Contractor:  TIANCHEN CORP. CHINA	Project :	MKP Methanol Project			Owner :  شرکت کیمیای پارس خاورمیانه Middle East Kumiya Pars Co.
	Unit	General Technical	Phase	Detail Engineering	
	Doc. Title :	PACKAGE HAZOP			
Vendor :  新鼎信息技術(上海)有限公司 Advanced Control & Information Technologies Co., Ltd.	Owner No.	MKP-11-DE-9000-SF-RPT-001B			Rev. : 0
	Contr. No.:	MKP-11-DE-9000-SA01-RPT-001B			
	Vendor No.	16E2416A			Page : 1 of 25

PACKAGE HAZOP

Node 3006

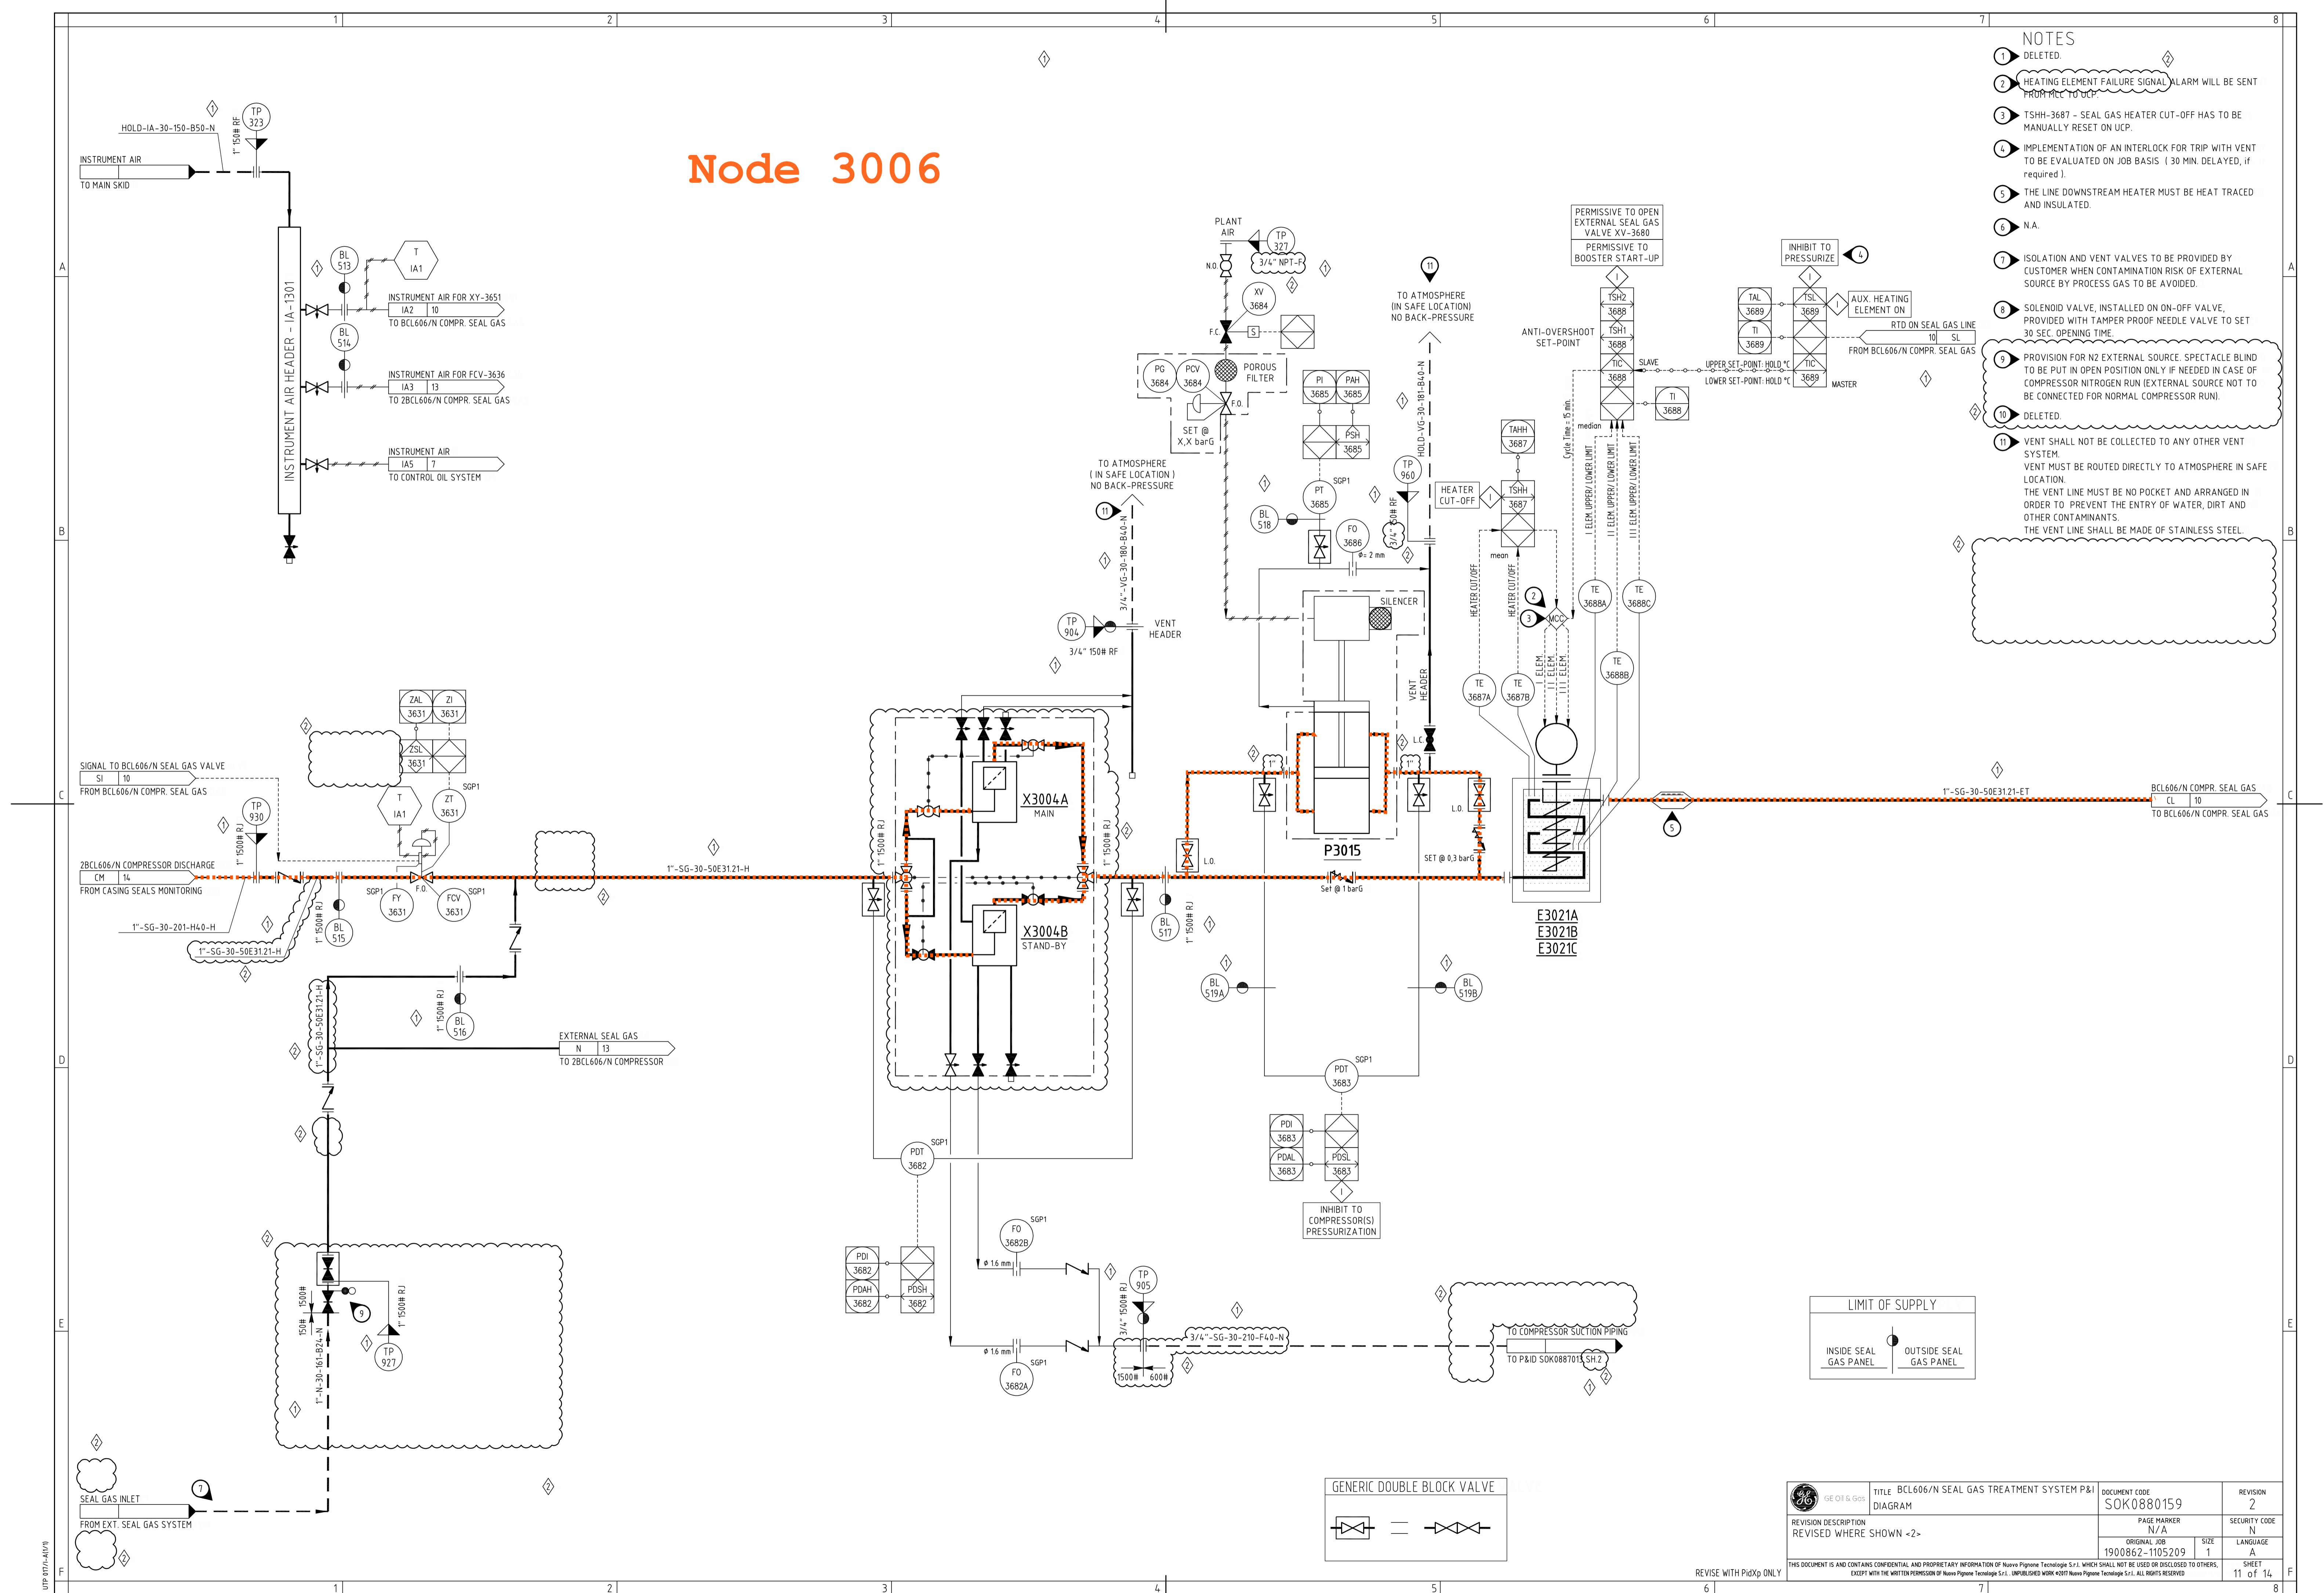
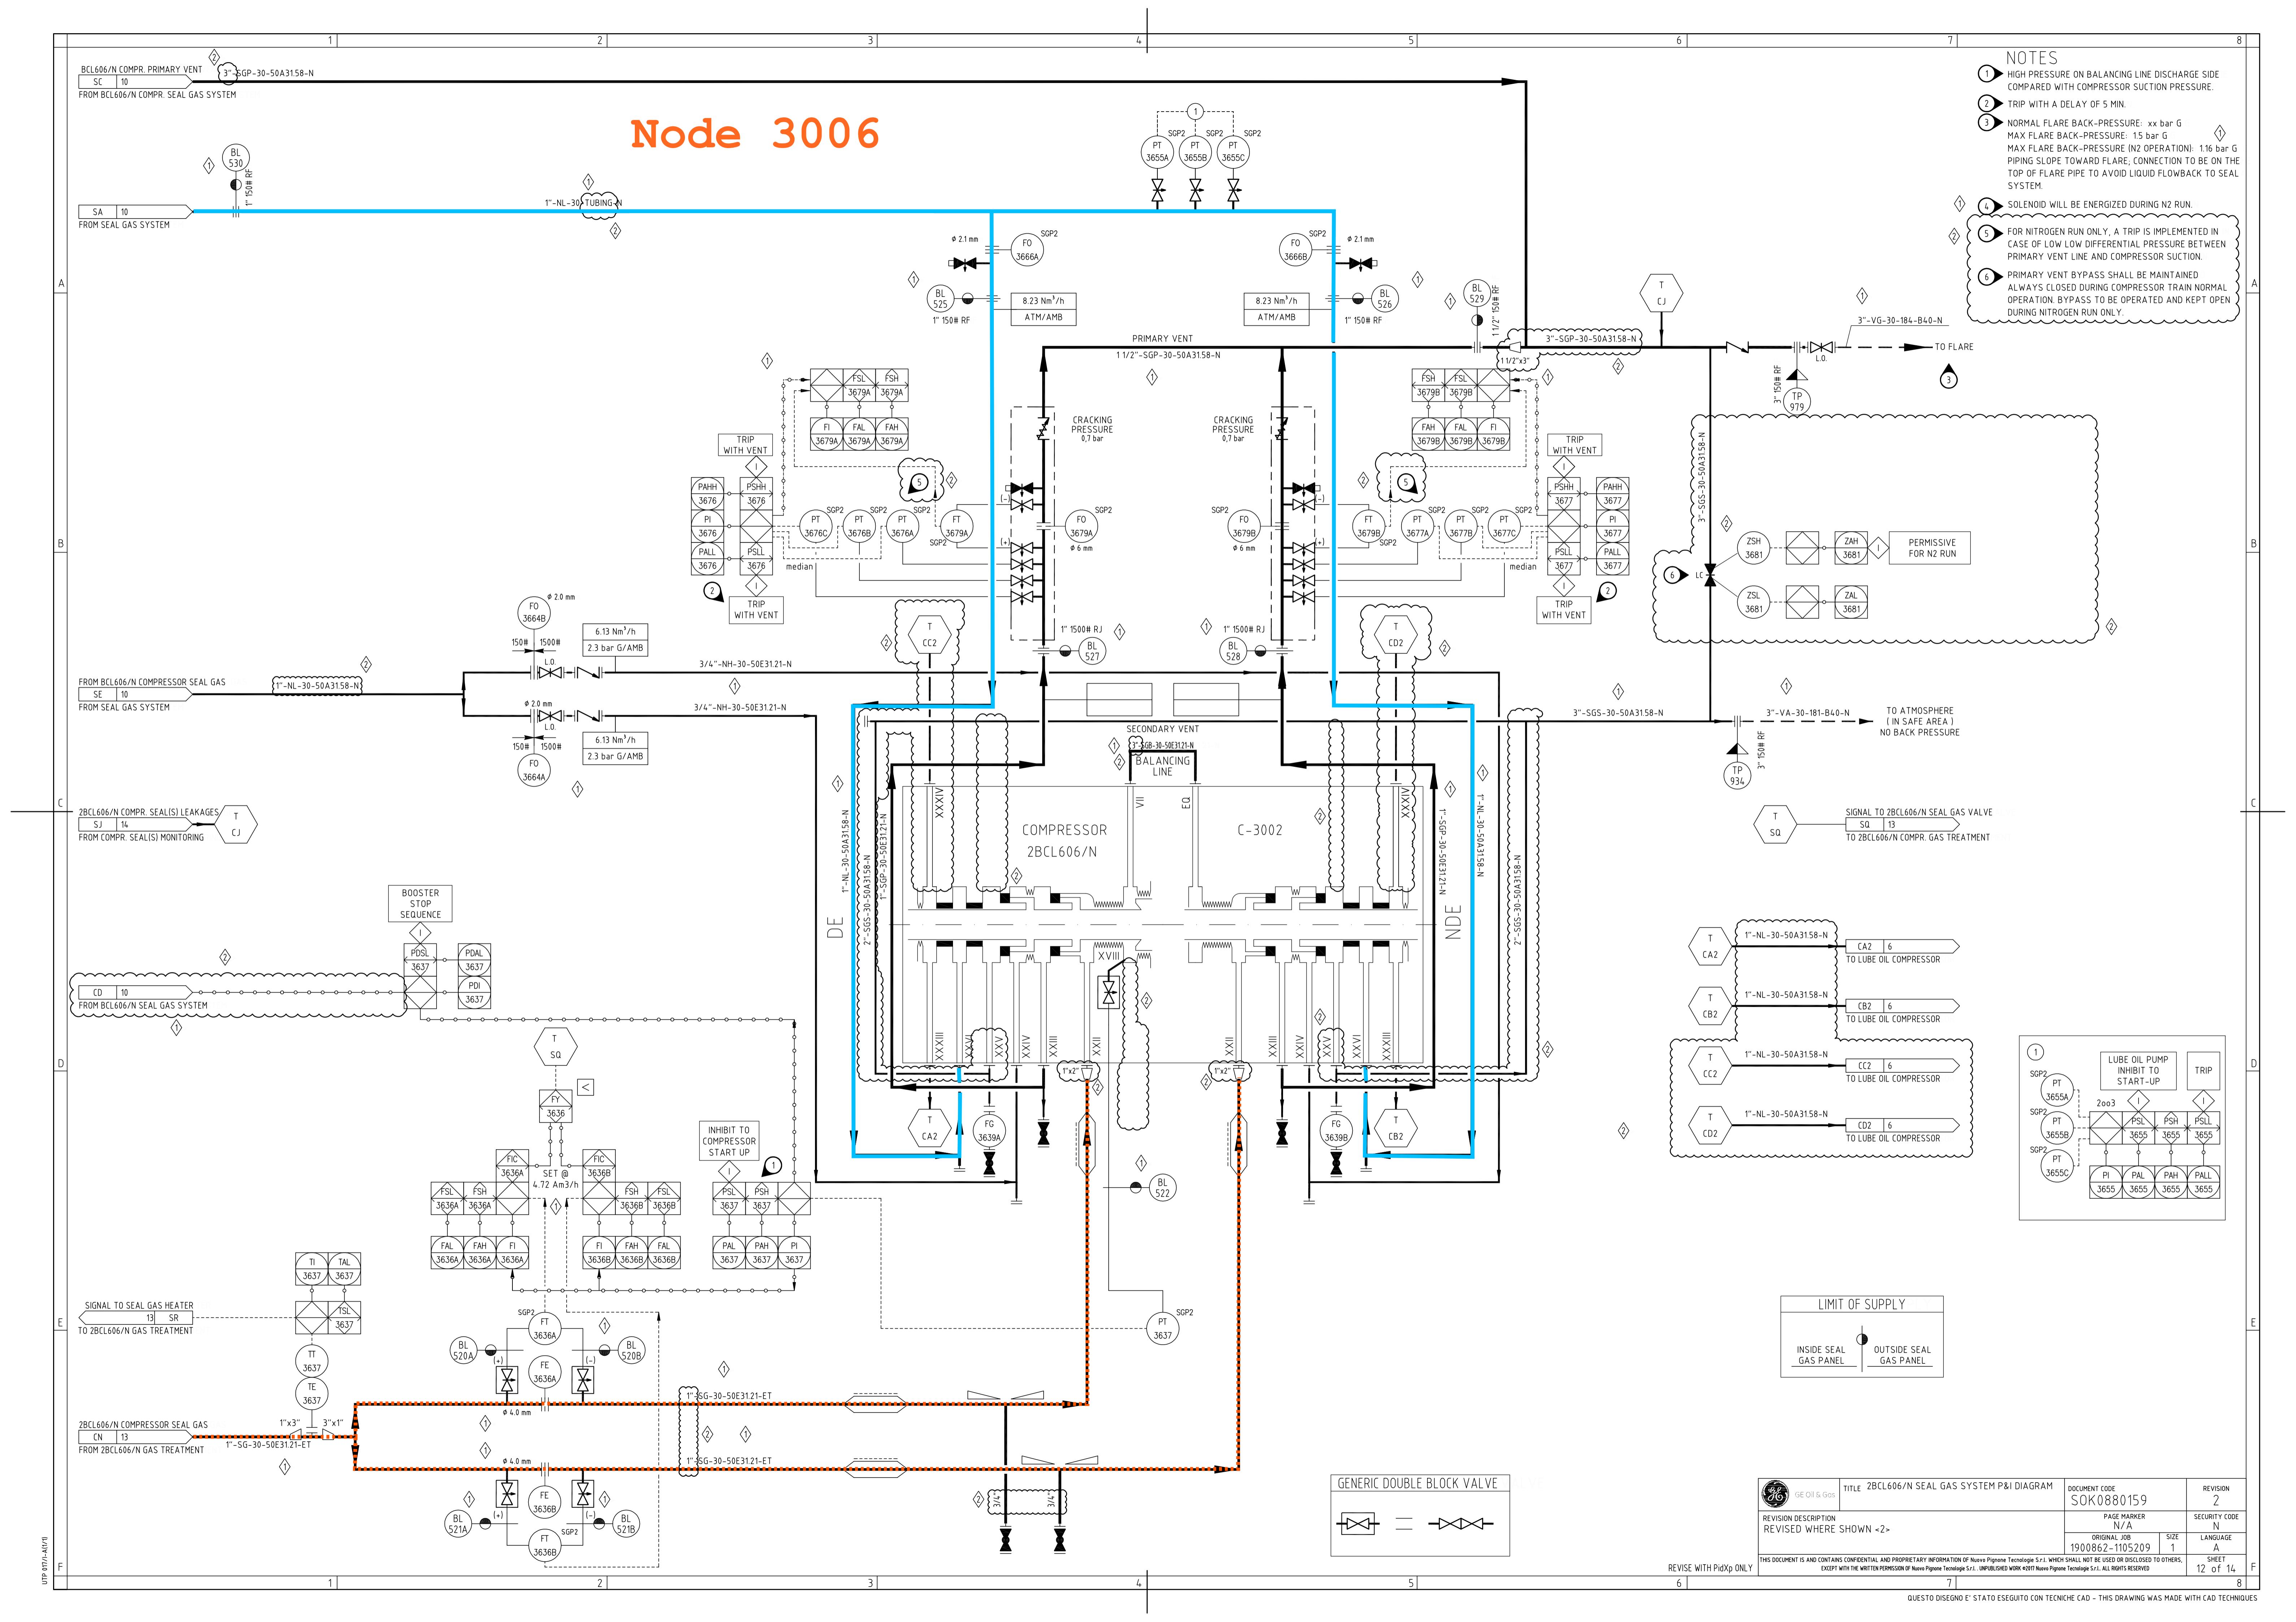
3006.14	3	Add high level alarm at pot of sub flare header of compressor house area 3000 and show this pot on P&ID no. 8500-PID-002.	Y			TCC
3006.19	3	Add high temperature alarm on TT-3744.	Y			GE
3006.21	3	Add high temp. alarm for TI-3722.	Y			GE
3006.24	3	to check the capacity of the breathing valve according to the max. gas blow.	Y			TCC
3006.26	3	to check the capacity of the breathing valve according to the max. gas blow.	Y			TCC
3006.32	3	GE provide the information about the oil quantity between the main pumps suction loss level and emergency pump suction loss level.	Y			GE
3006.47	2	Operation Procedure should be placed that stop the steam turbine and remove the vacuum from the condenser in case of loss of LP steam. (To be mentioned in GE operation manual of the compressor package, and incorporated in the plant operation manual.)	Y			GE

Node 7007

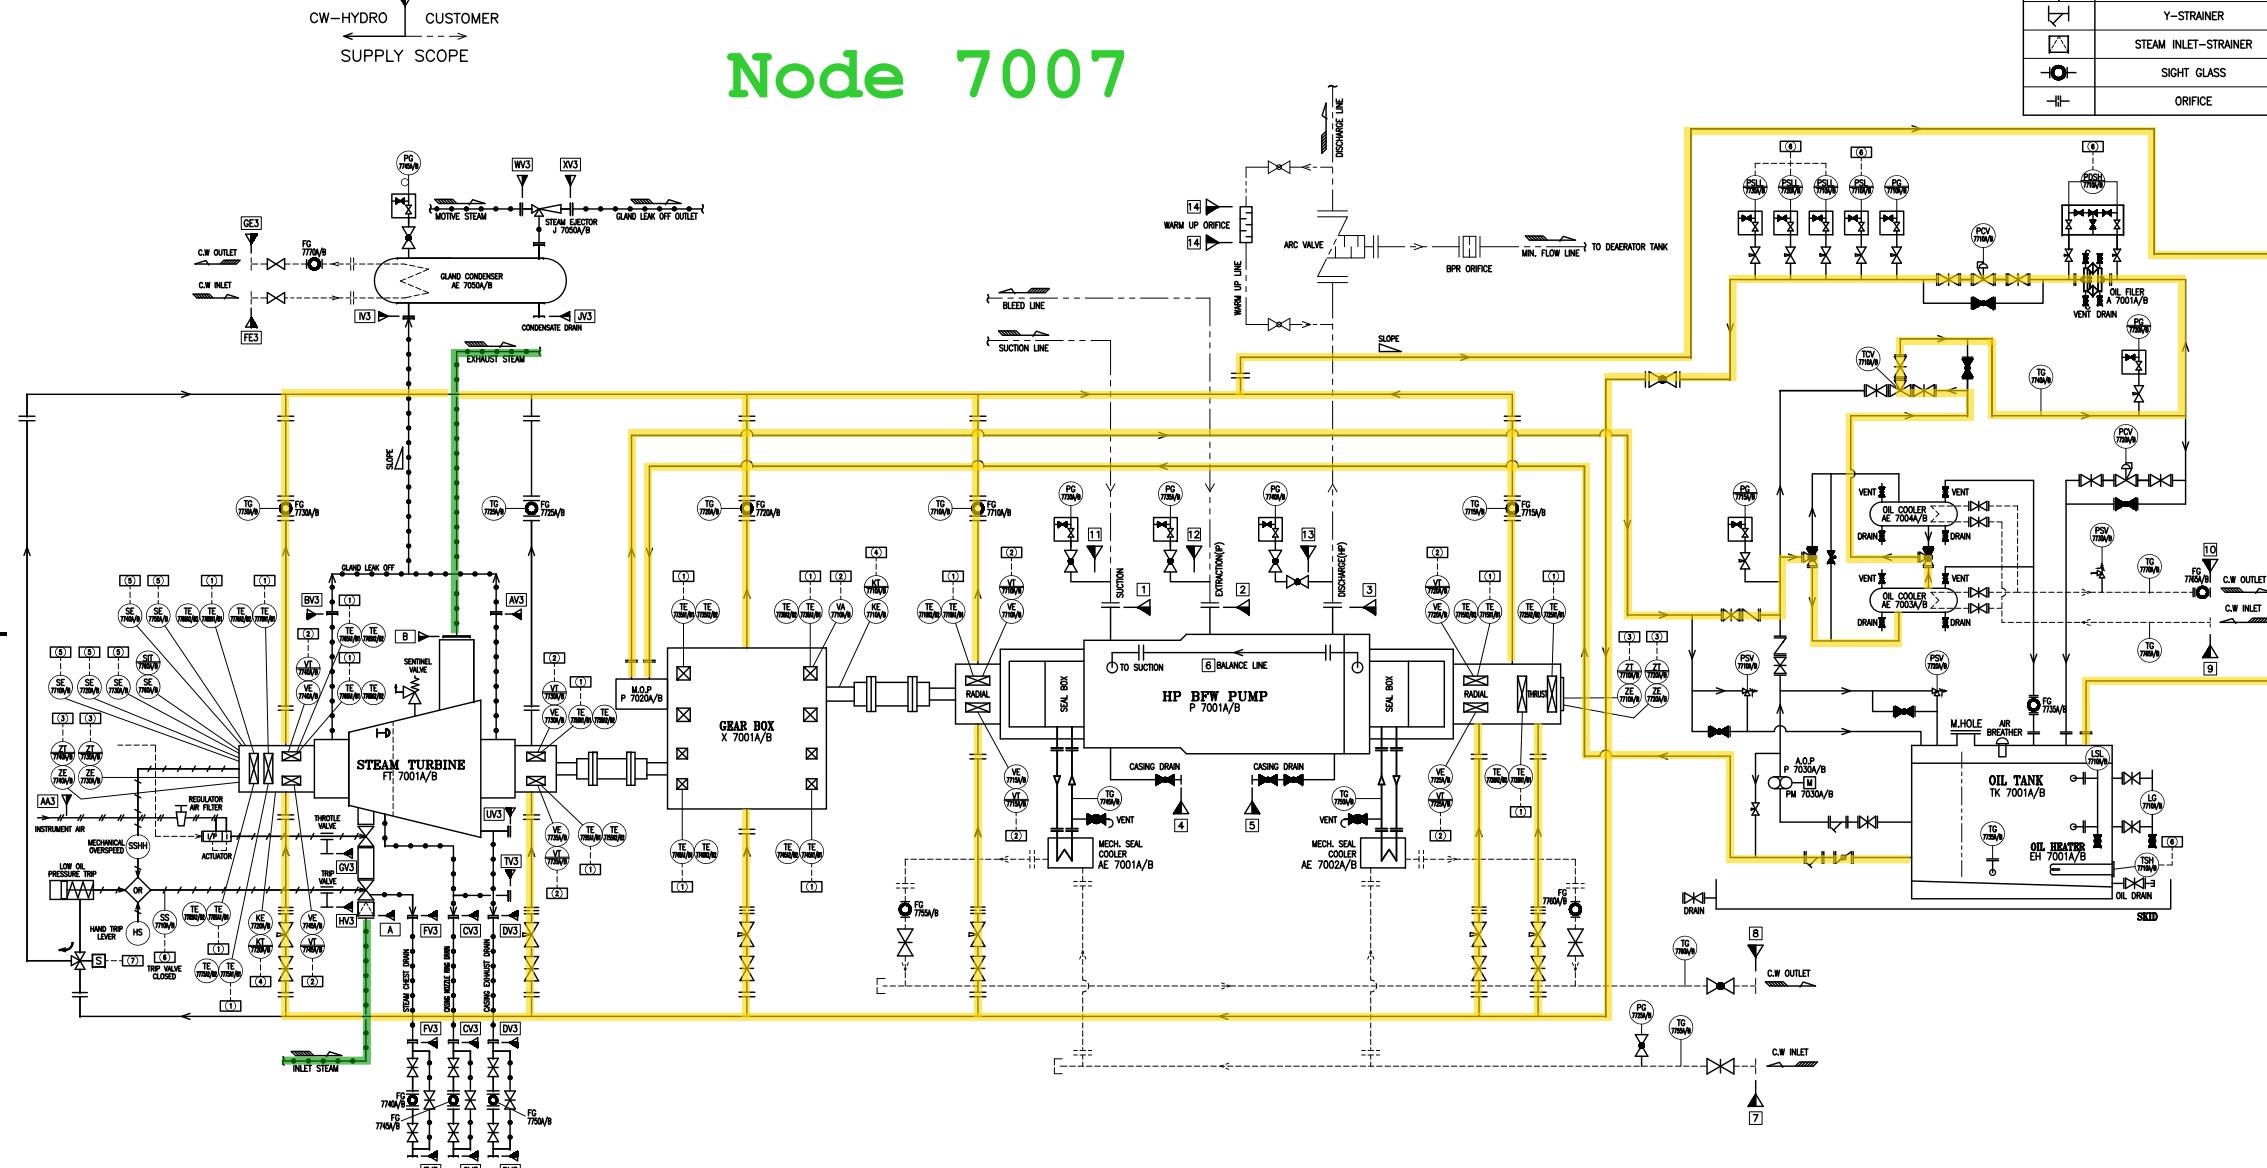
7007.4	3	1.Cancel PSL-7710A/B/C switch. 2.Use transmitter instead of all switch(PDT-7710A/B/C, PT-7710A/B/C, 7720A/B/C, 7730A/B/C and others). 3.PT-7710A/B/C, 7720A/B/C, 7730A/B/C (medium of 3) low pressure alarm and start the auxiliary oil pump, low low pressure(2003) to trip.	Y			CW-Hydro
7007.6	3	Add high temperature alarm and high high temperature trip at turbine inlet pipe.	Y			CW-Hydro
7007.7	2	Add TT high temperature alarm and high high temperature trip at turbine outlet pipe.	Y			CW-Hydro
7007.8	2	Add low temperature alarm and auto start oil heater EH-7001A/B/C.	Y			CW-Hydro
7007.9	2	Add low level alarm and low low level trip for LSL-7710A/B/C.	Y			CW-Hydro

7007.11	3	1.Add low pressure and low temperature alarm at turbine inlet utilizing inlet PT and TT to send signal to CW-Hydro PLC. 2.Add minimum allowable low continuous speed alarm.	Y			CW-Hydro
7007.13		Due to absence of CW-Hydro representative in HAZOP meeting, some HAZOP items will be checked by Owner later. As the latest P&ID of vendor are not received in HAZOP meeting, further recommendations can be stated later. TCC should prepare the latest P&IDs of this package and send them to Owner during two weeks.	Y			CW-Hydro / TCC
7008.1	3	Add high pressure alarm and high high pressure trip at turbine inlet utilizing inlet PT to send signal to CW-Hydro PLC.	Y			CW-Hydro
7008.2	3	Add high pressure alarm and automatic stop auxiliary oil pump.	Y			CW-Hydro

. 8	low temperature(Lube oil)	1.External low temperature. 2.Cooling water overflow.	1.Viscosity of lube oil increase and cause shaft to wear out and damage turbine and BFW pump. 2.Decrease the performance of lube oil pump and decrease the oil supply. 3.Increase d/p of the filter.	1.Lube oil heater will switch on when external low temperature. 2.PDSH-7710A/B/C d/p switch for filter.	2	4	2	N	Add low temperature alarm and auto start oil heater EH-7001A/B/C.
. 9	low level (oil tank)	1 1.Oil tank leakage. 2.Pipe leakage. 3.Drain abnormally open.	1.No oil to the bearings. 2.Damage oil pump.	1.LSL-7710A/B/C low level switch. 2.PSLL-7710A/B/C, 7720A/B/C, 7730A/B/C low low pressure switch. 3.Blind after the drain valve.	3	3	2	N	Add low level alarm and low low level trip for LSL-7710A/B/C.
